Groundwater and Wastewater Services File Imaging Project

Mecklenburg County
Health Department

RE: File No. 7253A. Property located on Lawyers Road.

Pre-Preliminary 137-066-20

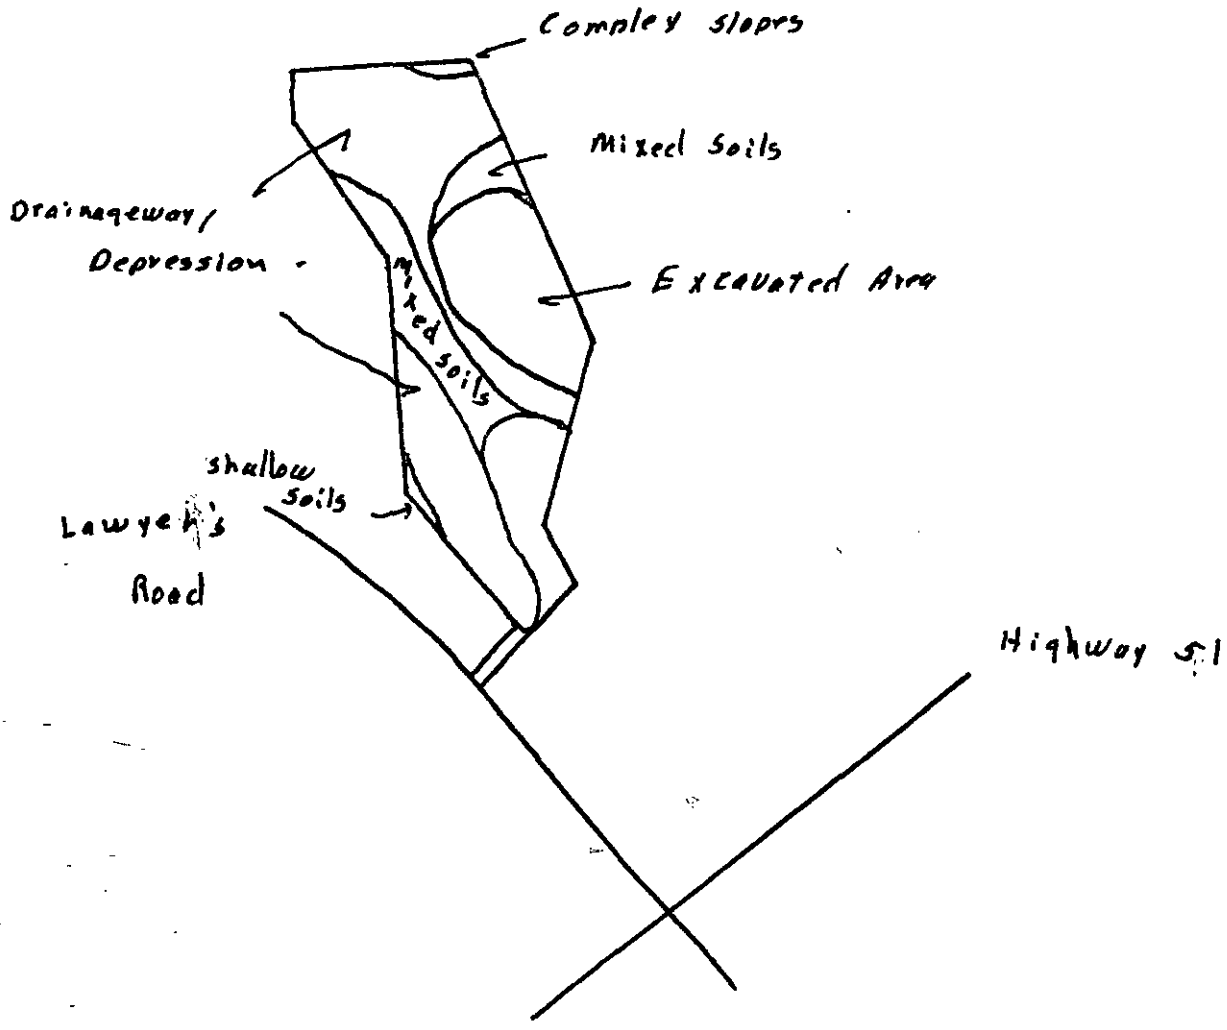
The soils in the unshaded areas on the enclosed map appear to be dominantly unacceptable for the installation of septic tank systems. Included are areas of mixed soils, drainageway-depressions, a small complex slope area, an excavated area and a small area of shallow soils. The mixed soil areas have expanding clay minerals that swell upon becoming wet, reducing soil pore space and internal soil water movement.

The drainageway-depression areas collect and channel surface runoff from the surrounding land areas. These areas could be subject to some surface flooding during periods of precipitation. These areas also have soils that exhibit internal soil drainage problems.

The complex slope area has slopes that are too rough and irregular for the installation of septic tank systems.

The excavated area has been shaped so that surface water collects in it during periods of precipitation. There are some areas in this delineation that have slopes that are not adaptable for the installation of septic tank systems.

There is a small area of shallow soils located on the tract. These soils have clay subsoil horizons that are blocky with respect to structure. Depth to ground water is greater than 36 inches. Saprolite depth is approximately 24 inches. This is a small area that does not appear to have adequate space for septic tank system installation.

The area shaded yellow on the enclosed map appears to be dominantly acceptable for the installation of septic tank systems. These soils have clay subsoil horizons that are blocky with respect to structure. Depth to ground water and saprolite is greater than 36 inches. Slopes range to approximately 10 percent. There are some irregular slopes in this delineation that could not be used for septic tank system installation.

Based on this investigation, the majority of the tract appears to be dominantly unacceptable for the installation of septic tank systems. Please note that this report does not express or imply individual site approval for septic tank system installation. Individual site approval is dependent in part on the satisfactory completion of an investigation of each site as of February 11, 1991, no sites were marked on the tract. Note also that inclusions of soils other than those delineated may occur. Please contact me if there are any questions.
